HISTORIC AND DESIGN REVIEW COMMISSION

HDRC CASE NO: 2021-057
ADDRESS: 1235 E CROCKETT ST
LEGAL DESCRIPTION: NCB 1373 BLK 1 LOT S 125 FT OF 27
ZONING: RM-4, H
CITY COUNCIL DIST.: 2
DISTRICT: Dignowity Hill Historic District
APPLICANT: Kali Tripp/Tripp Flip, LLC
OWNER: Kali Tripp/Tripp Flip, LLC
TYPE OF WORK: Removal of an existing front door
APPLICATION RECEIVED: January 27, 2021
60-DAY REVIEW: Not applicable due to City Council Emergency Orders
CASE MANAGER: Edward Hall

REQUEST:

1952 SANBORN MAP

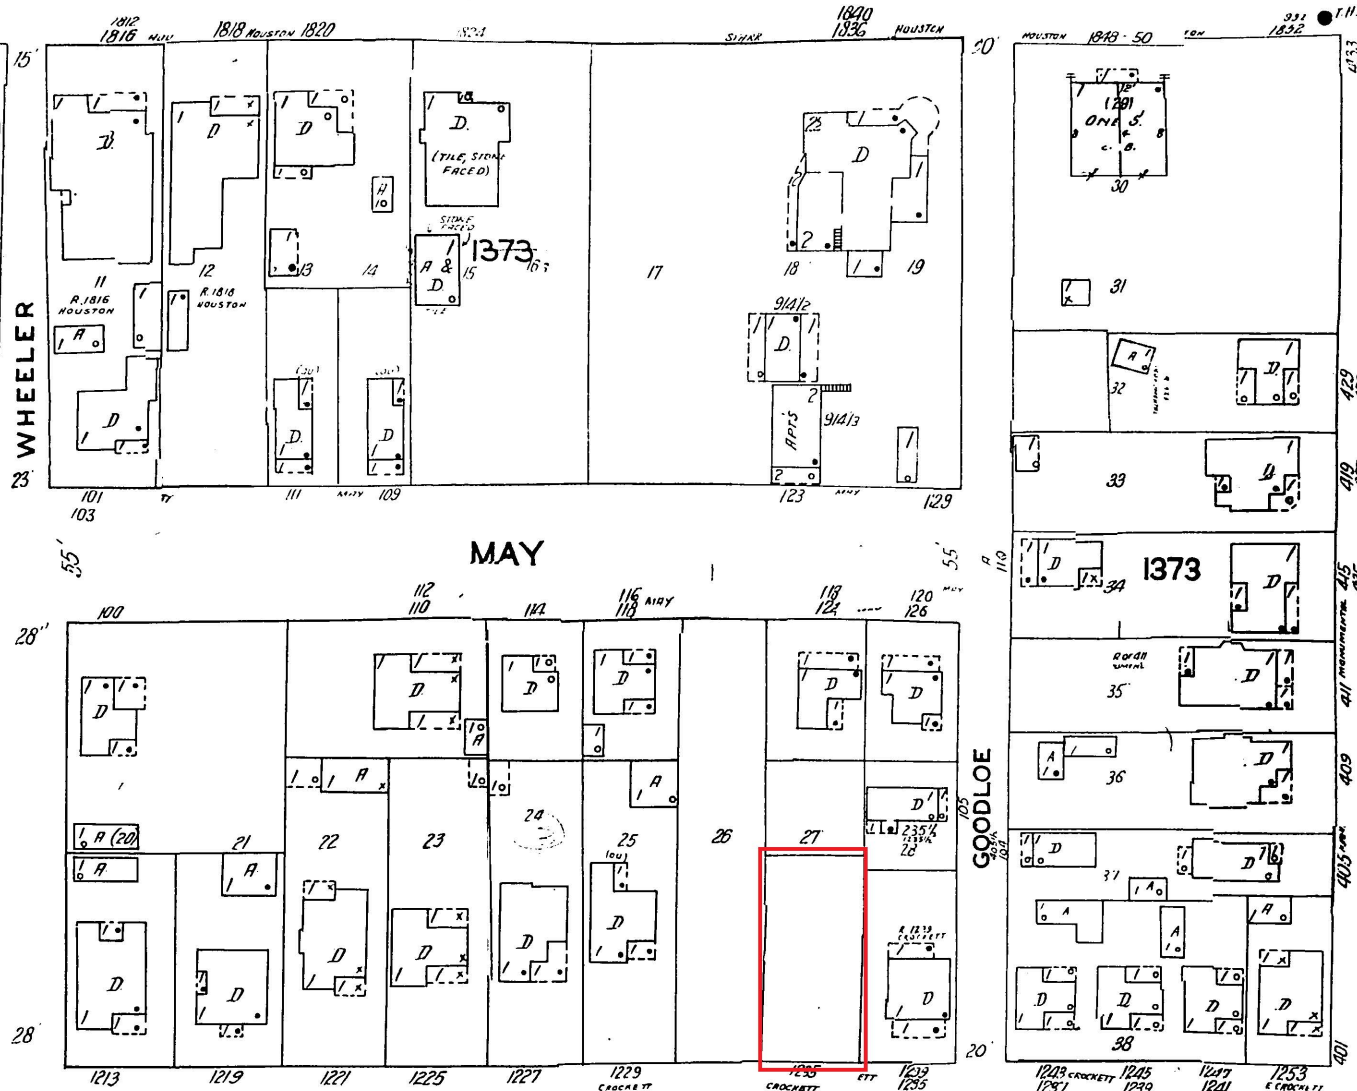
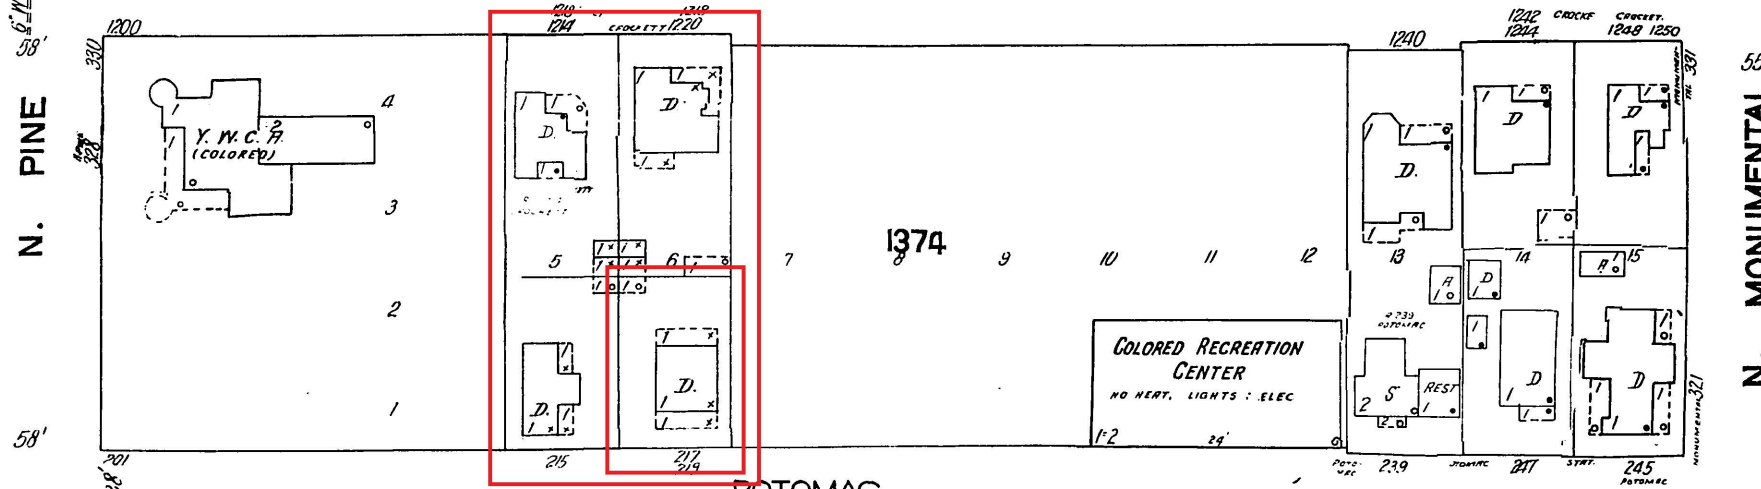
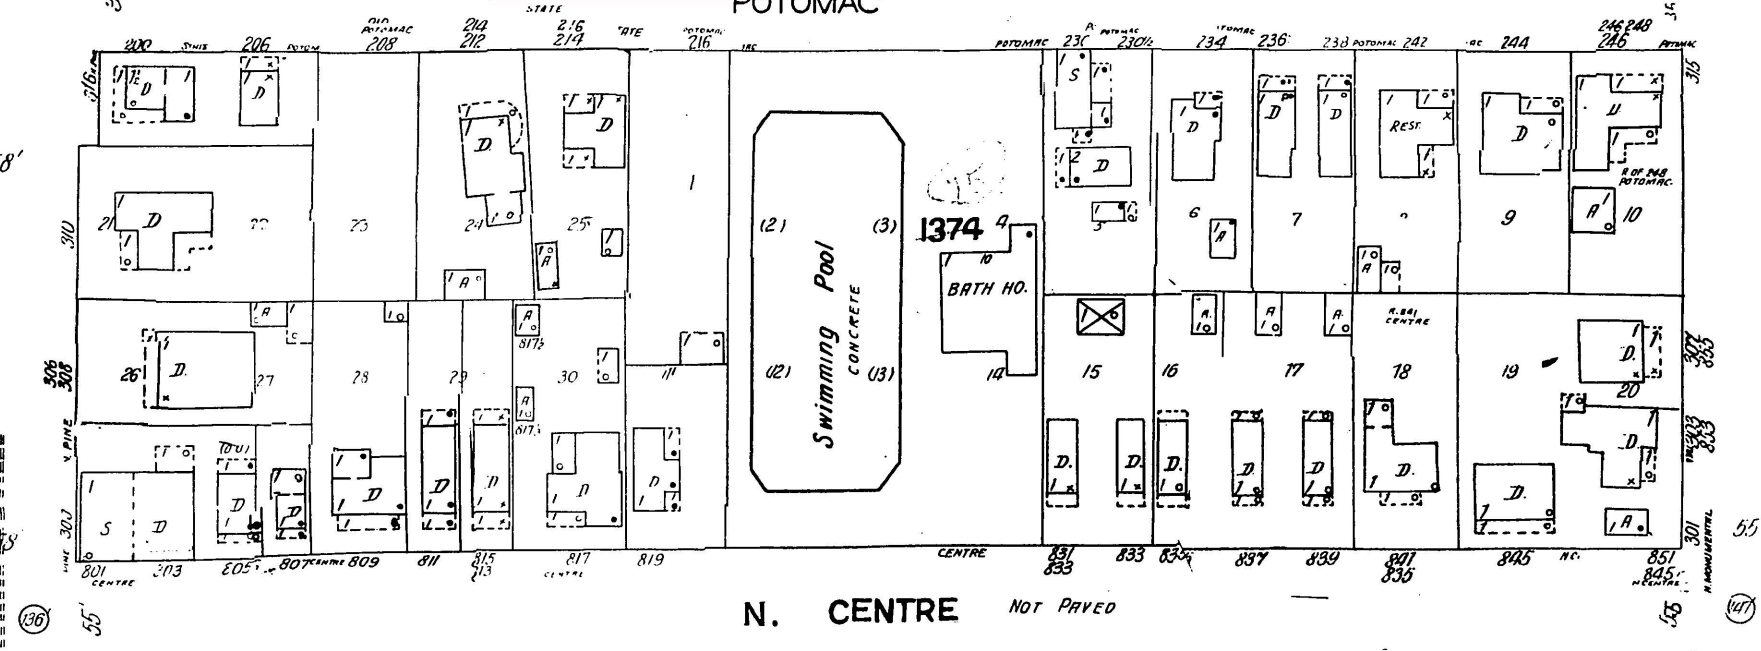
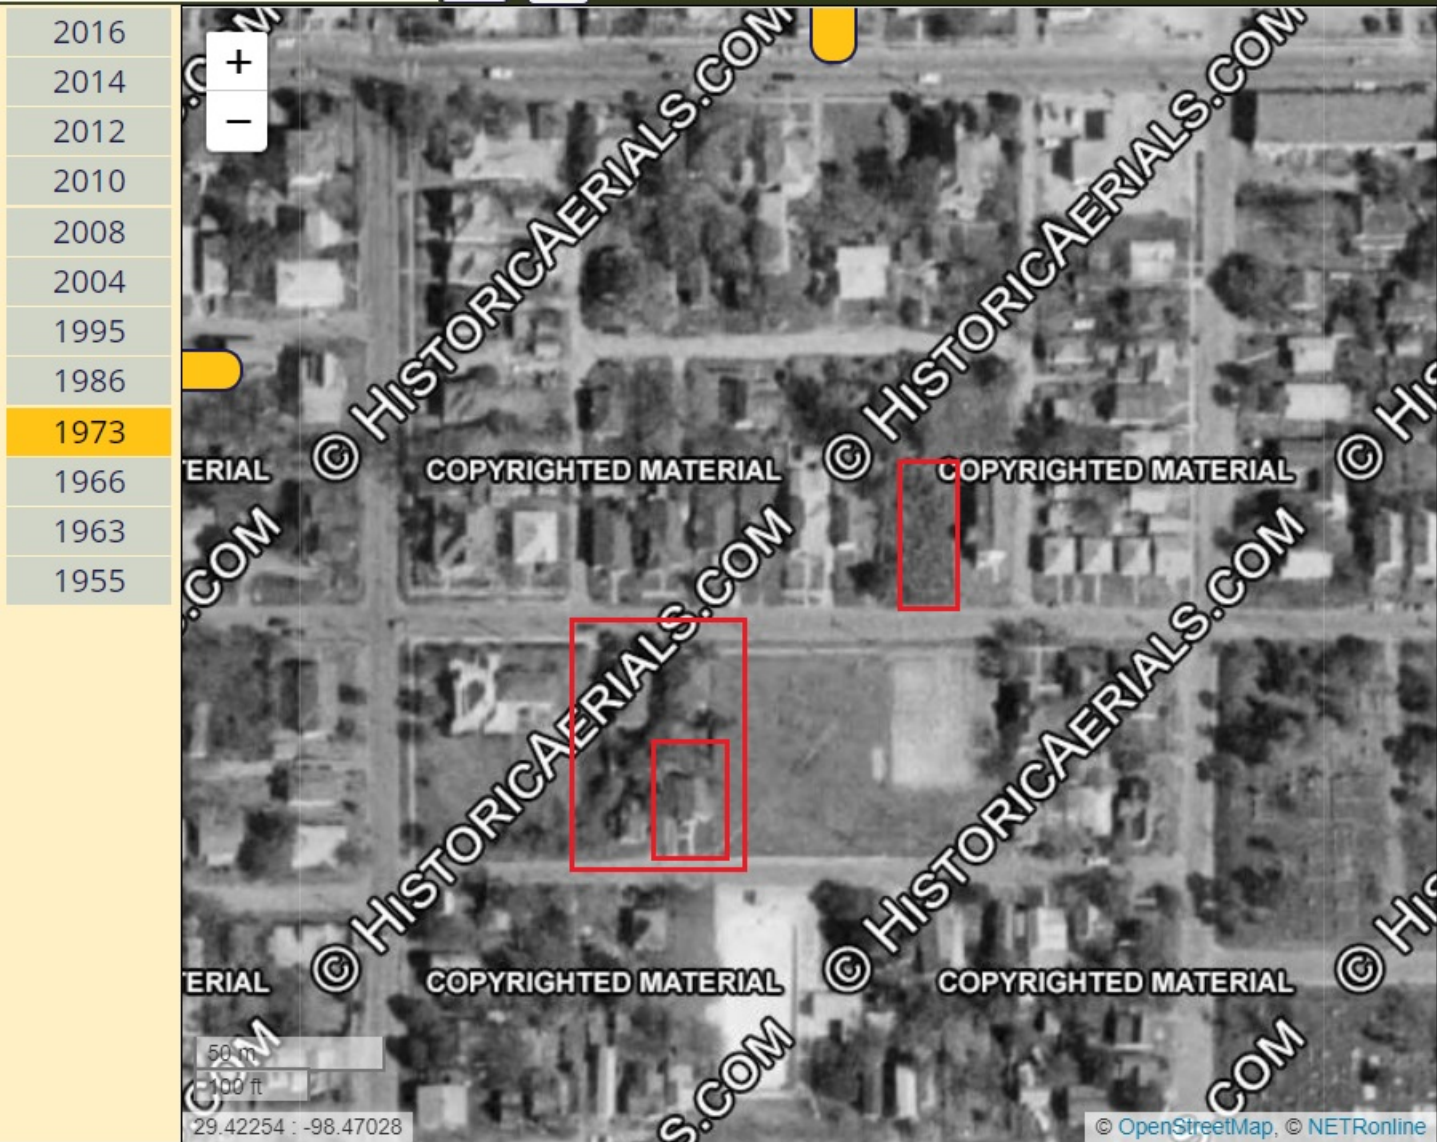
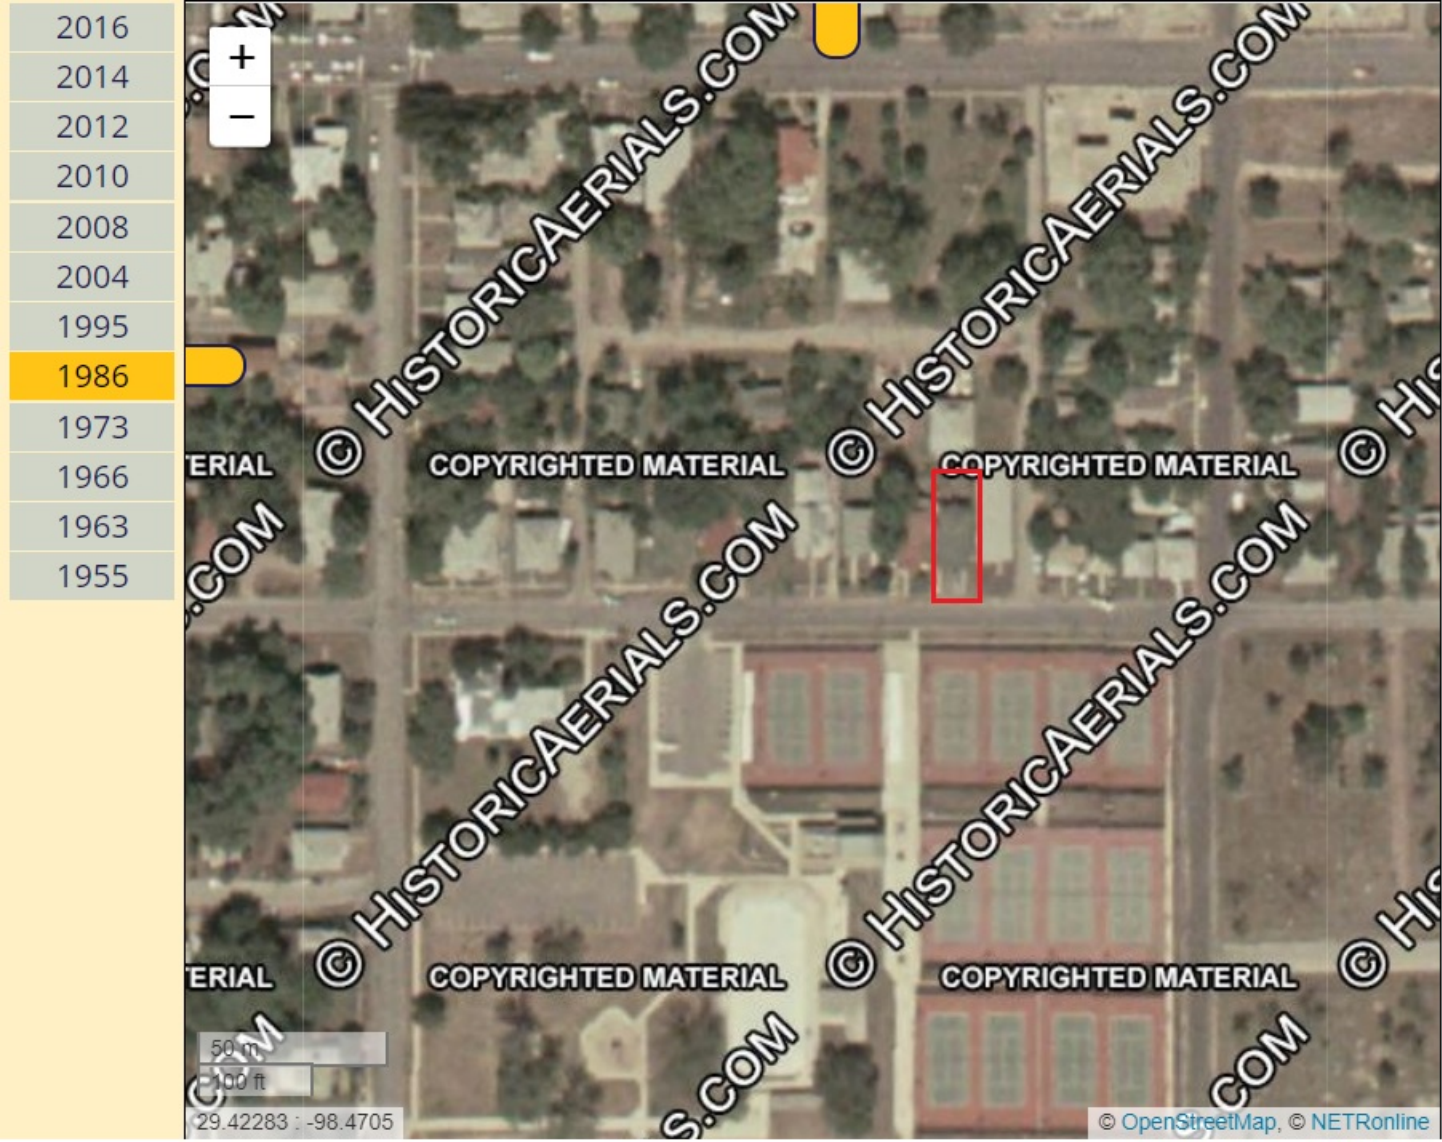
- b. The historic structure located at 1235 E Crockett first appears on aerial photographs at its current location in 1986. The structure was relocated to its current location at an undetermined time; speculatively during the construction of Fairchild Park, where a number of historic structures were removed from their original locations. The original structure located at 1235 E Crockett is noted on the 1931 Sanborn Map as “partly burned” and was no longer present at the lot by 1952. OHP staff has not found a reference to the historic structure in its original location; however, there is a duplex structure found on the 1912 and 1952 Sanborn Map. Interior framing suggests that the structure may have featured a recessed front porch with street facing and side yard facing front doors; however, this has not been verified via Sanborn Maps or other historic information.

FLOOR PLAN - PROPOSED

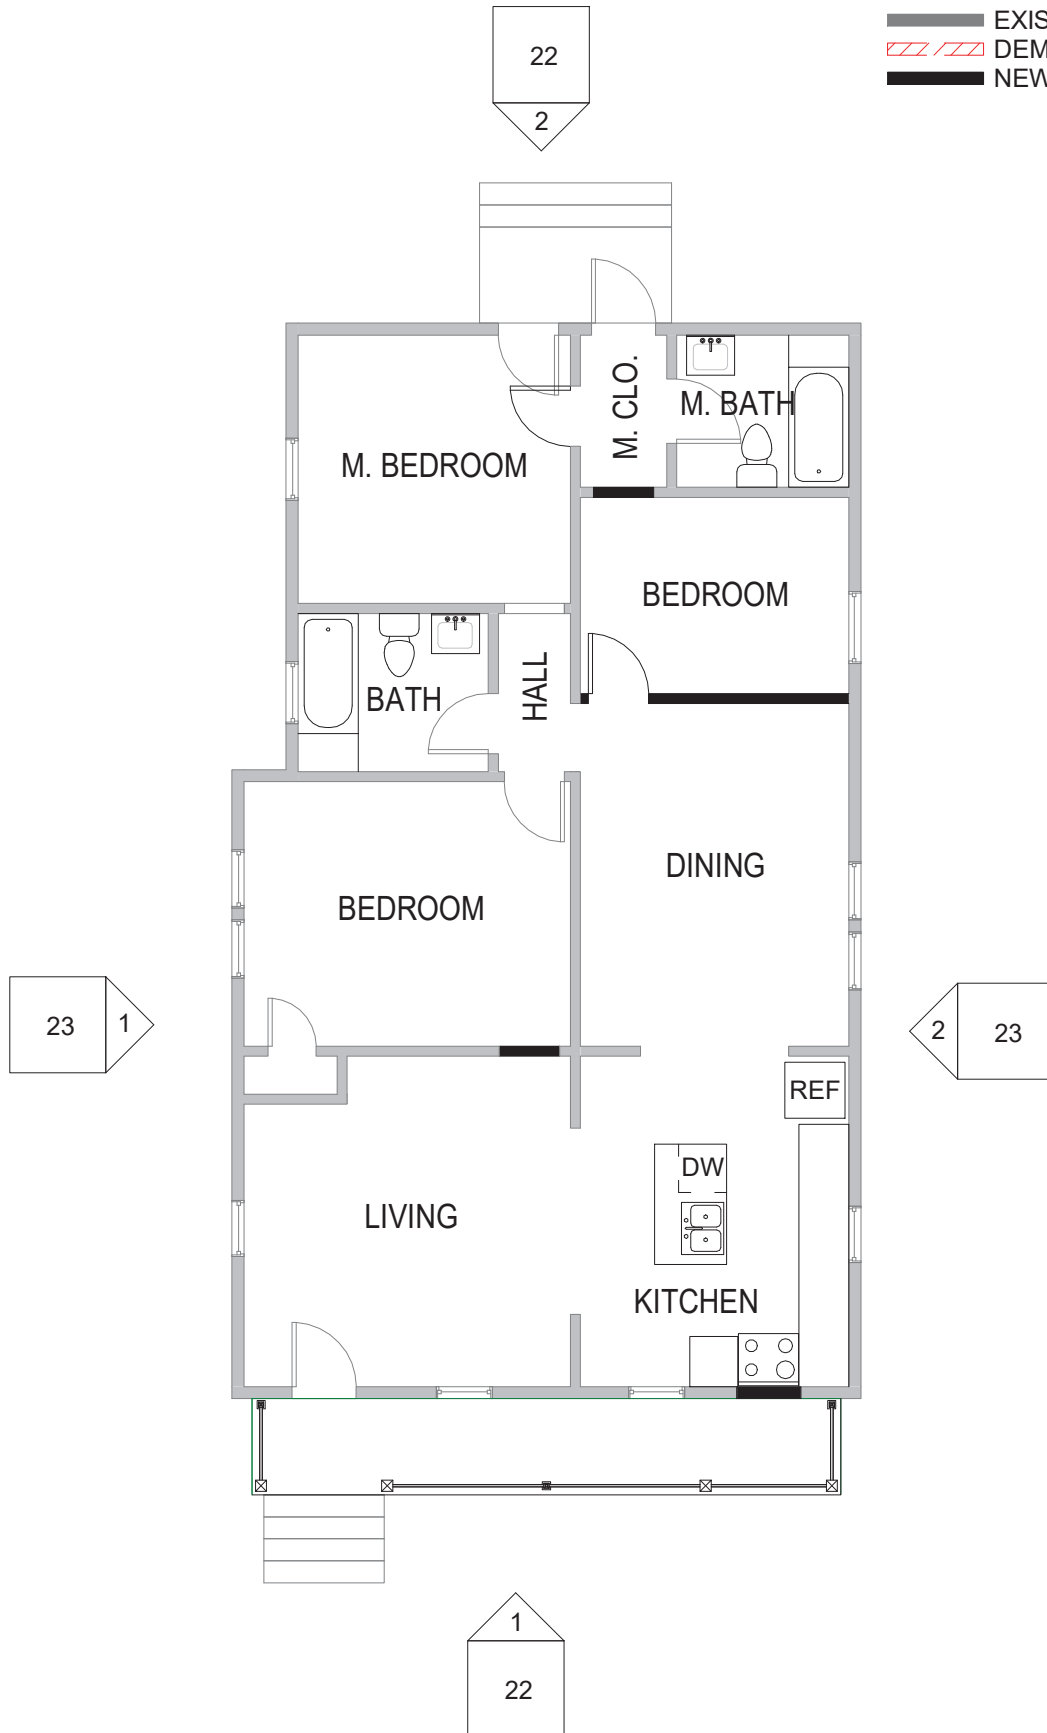
- c. DOOR REMOVAL – The Historic Design Guidelines note that original window and door locations should be preserved as they exist. Staff has not found sufficient evidence that alludes to the historic structure having not been a duplex. Staff finds that maintaining both front doors provides an architectural reference to the structure’s historic form.

Staff does not recommend approval of the proposed door removal based on findings b and c.

FLOOR PLAN - DEMOLITION

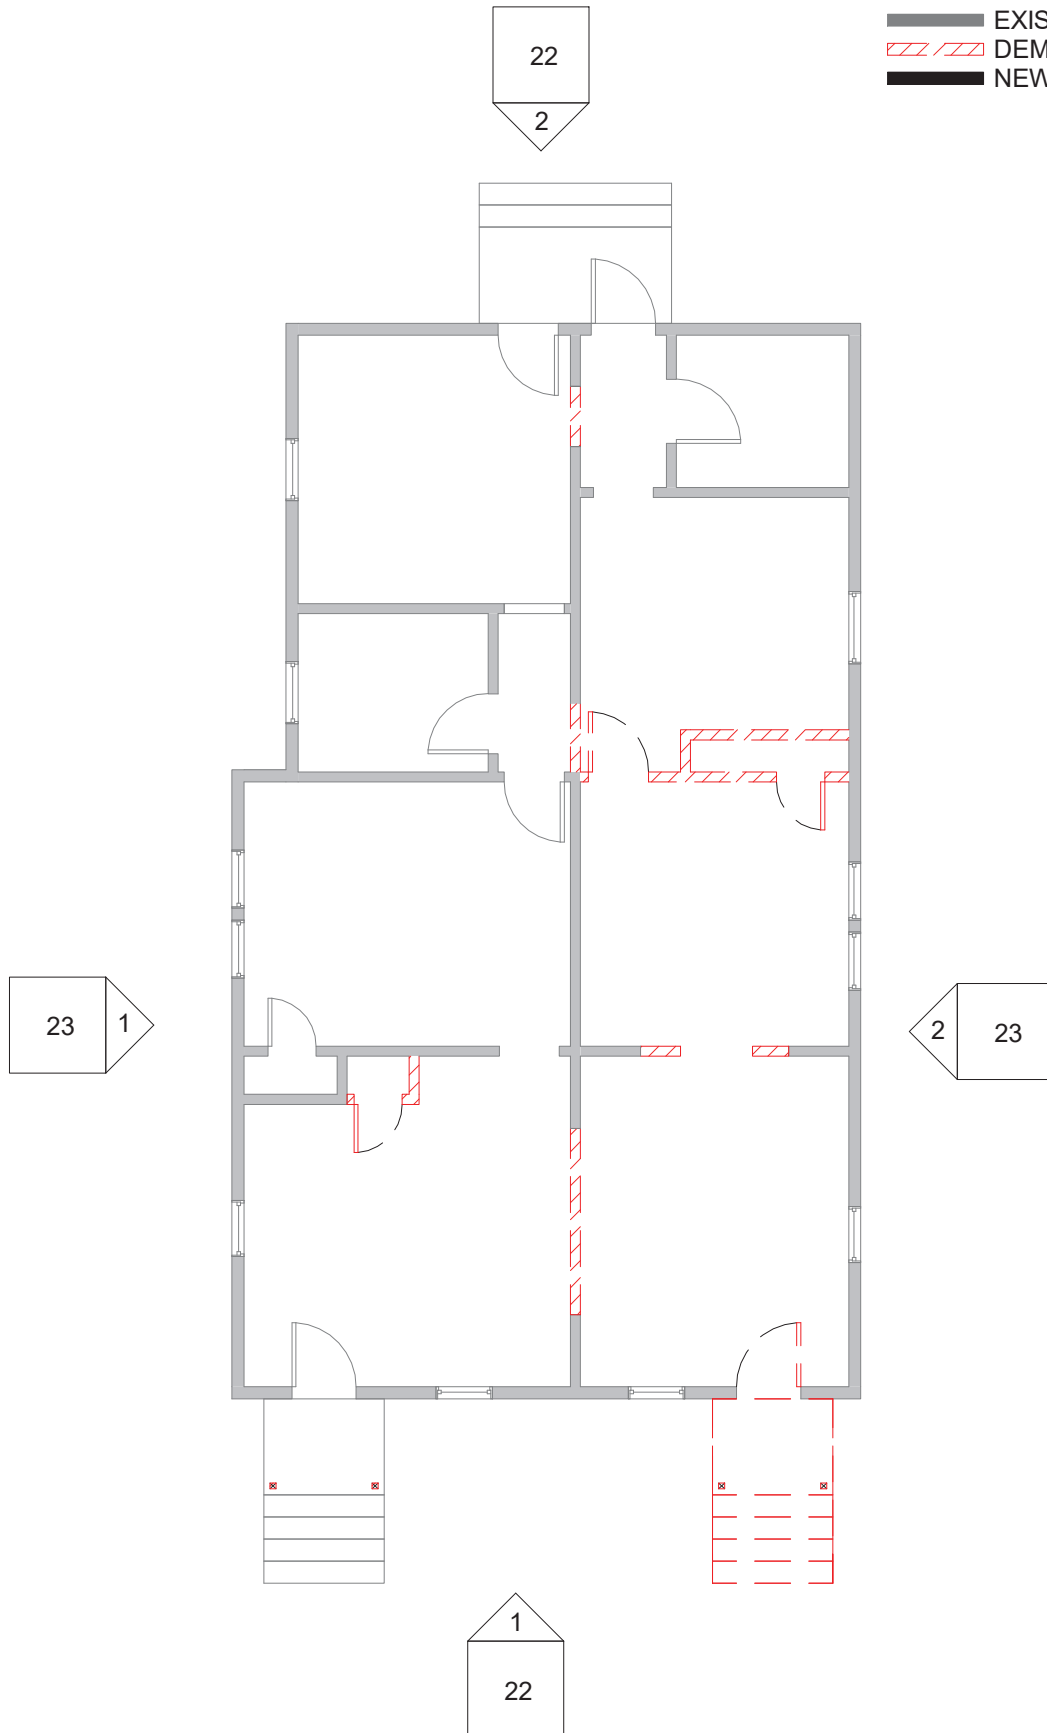
After demolition of interior of property, it was discovered that the original home was in fact a single-family home.

- Two doorways leading from the separate “units”, or sides, of the home are in the original framing.
- The second door is not original to the home’s framing, but was cut in at a later time.
